MIL-S-19500/331A(EL)
AMENDMENT-2

29 January 1974
SUPERSEDING
AMEND-1
15 June 1971

SEMICONDUCTOR DEVICE, TRANSISTOR, PNP, GERMANIUM
TYPES 2N1553A through 2N1556A

This amendment forms a part of Military Specification MIL-S-19500/331A(EL) dated 8 February 1971 and is approved for use by all Departments and Agencies of the Department of Defense.

FIGURE 3 Safe operating Area curves.

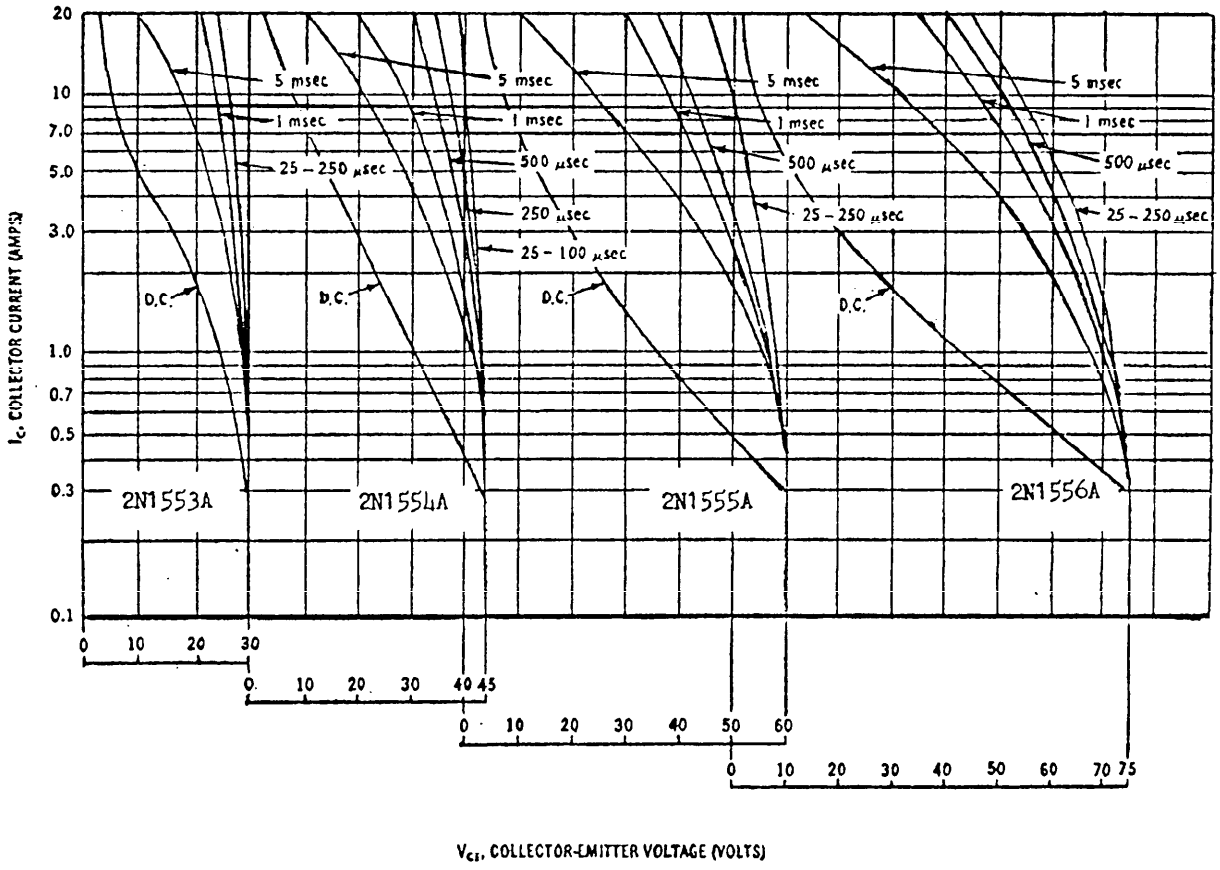
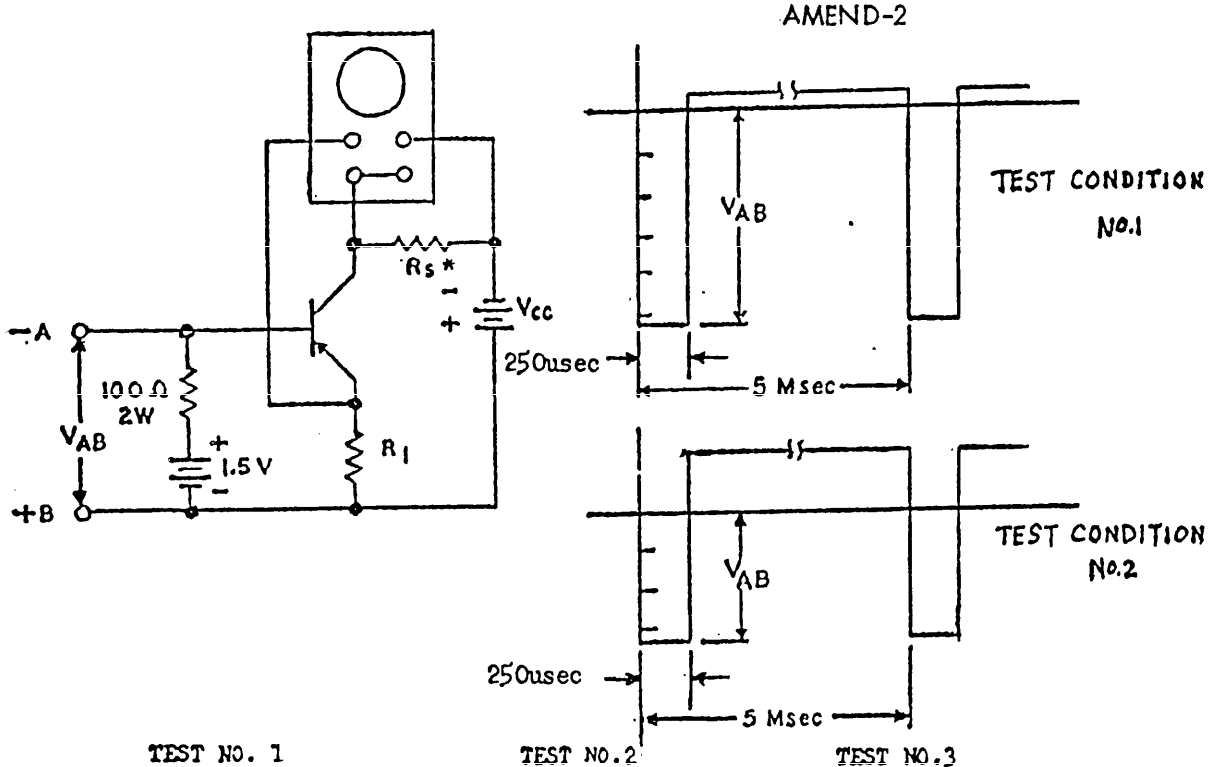
Figure 3: Remove and substitute the attached Figure 3.
